Ducted Systems Technical Services: Service Tips Letter

Letter: ST-008-2021

Subject: **16 SEER Modulating Heat Pump Circuit Breaker**

Product/s: **YHM, TH16, CH16 Residential Heat Pump Models**

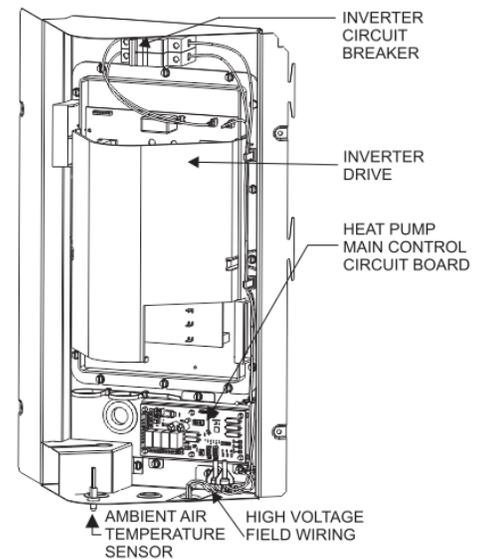
Since the introduction of the modulating heat pump product, in very specific installations some customers have experienced nuisance circuit breaker tripping. The circuit breaker can be found in the upper area of the unit control panel as shown in the image to the right. The breaker may inadvertently trip during periods of high or excessive outdoor ambient temperatures. The internal breaker was designed into the product to add an extra layer of current protection for the electronic inverter drive. The breakers were selected based upon the listed minimum circuit ampacity (MCA) as well as operating temperature limit conditions found in Table 1 of the unit installation manual. Even though an external service disconnect and branch circuit fuse or breaker should already be installed per electrical code and in accordance with the outdoor unit installation instructions, agency requires the internal breaker on the product. If an installation experiences nuisance trips of the internal circuit breaker and all troubleshooting steps have been followed to validate the system is working properly, the internal breaker may be replaced with a different breaker per the table below. New unit production will also change to the updated breakers. This will be a running change. The unit model number will not change however the revision letter (at the end of model number) will change from revision "A" to revision "B". The revision letter is only visible on the unit rating plate itself. There will be no change to the units MCA or maximum over-current protection device (MOP) rating therefore there will be no change in unit ratings.

UNIT TONNAGE	CIRCUIT BREAKER P/N
2	S1-02436306000
3	S1-02436307000
4	S1-02436308000
5	S1-02440909000
